UNITED STATES PATENT AND TRADEMARK OFFICE

Office Action Summary	Application No. 10/576,560	Applicant(s) HEMMINGSON, OLLE	
	Examiner BHARAT C. PATEL	Art Unit 3724

DETAILED ACTION

FIG. 5

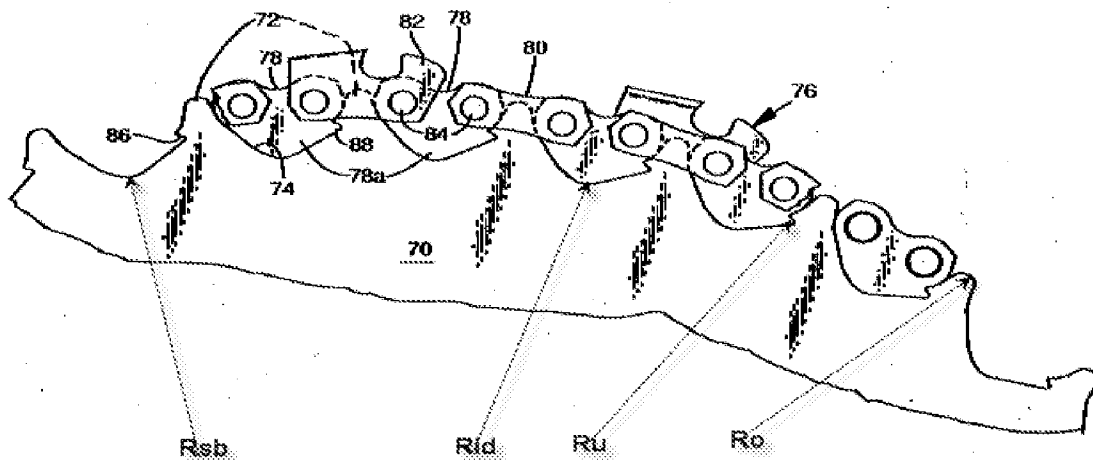
Re claim 1, Carlton discloses disc saw blade 60 with a saw chain 76 mounted around the circumference of a circular disk 70, the saw chain 76 is provided with driving links 78, connecting links 80 and cutting links 82, wherein the chain 76 is guided by means of the driving links 78 in at least one chain groove. It should be noted that the groove is formed by plates 66, 68, and disc 72 per Fig.4 as explained in col. 3, lines 43-46. Carlton also discloses that the chain 76 is arranged around the periphery of the disk 70, against the bottom 74 of the groove, a projecting part 78a of each driving link that projects radially inwards can make contact, in that the bottom 74 of the groove has

radial projections 86 distributed around the circumference and the driving link has a cam surface 88 on the part 78a that projects radially inwards for interaction with the respective radial projection 86, and in that the chain 76 when driven, moves from a neutral position, in which the chain is loosely mounted around the circumference of the disk 70 and the projecting part 78a of the respective driving link 78 is loosely inserted between two adjacent radial projections 86, to a working position, in which the chain is tensioned around the circumference of the disk 70 and the cam surface 88 on the respective driving link is in contact with the associated radial projection 86 per Fig. 5; wherein the length of the saw chain 76 is matched to the radius "ro" of the disk 70, so that with the saw chain 76 and the disk 70 is arranged concentrically in the neutral position, a radius "Rid" to the projecting part 78a (bottom portion) of each driving link 78 is larger than a radius Rsb to the bottom of the groove 74 and less than a radius "Ru" to each projection 86 per modified Fig. 5 shown above. It should be noted that the equivalent markings of the radii is performed to clarify the understanding of relationship amongst various radii. As 78a portion of the driving link fits into the gulley area 74 of the disc 70, it is apparent and inherent that area of the portion 78a is smaller. Hence, the Rid, distance of the bottom portion of 78a to the center of the disc 70, is greater than the Rsb, the distance of the bottom (valley) portion of the gulley 74 with respect to the center of the disc 70.

Re claim 2, Carlton discloses that the cam surface 88 on each driving link 78 is designed to press the chain 76 radially outwards against the radial projection 86 by the

cam effect, in such a way that, in a tensioned state, the chain is held onto the disk 70 as a result of its shape per Fig. 5 and per col. 4, lines 3-36.

Re claim 4, Carlton discloses that the bottom 74 of the groove has a predetermined number of projections 86 distributed evenly around the circumference of the disk 70 per Fig. 5.

Re claim 5, Carlton discloses that the bottom 74 of the groove has one projection 86 for each driving link 78 per Fig. 5.

Re claim 6, Carlton discloses that radial cross-section of each projection 86 is lug shaped per Fig. 5.

Re claim 7, Carlton discloses that radial cross-section of each projection 86 is pyramid shaped per Fig. 5.

Re claim 8, Carlton discloses that radial cross-section of each projection 86 is dome shaped per Fig. 5.

Re claim 9, Carlton discloses that radial cross-section of each projection 86 is designed as a truncated cone that has a complementary shape to the cam surface 78a of the interacting driving link 78 per Fig. 5.

Re claim 11, as best understood, Carlton discloses that the construction of the chain 76 is such that the connecting links 80 are spaced radially outwardly with respect to radially outermost portions of the radial projections 86 when the chain is in a neutral position and when the chain is being driven per Fig. 5.
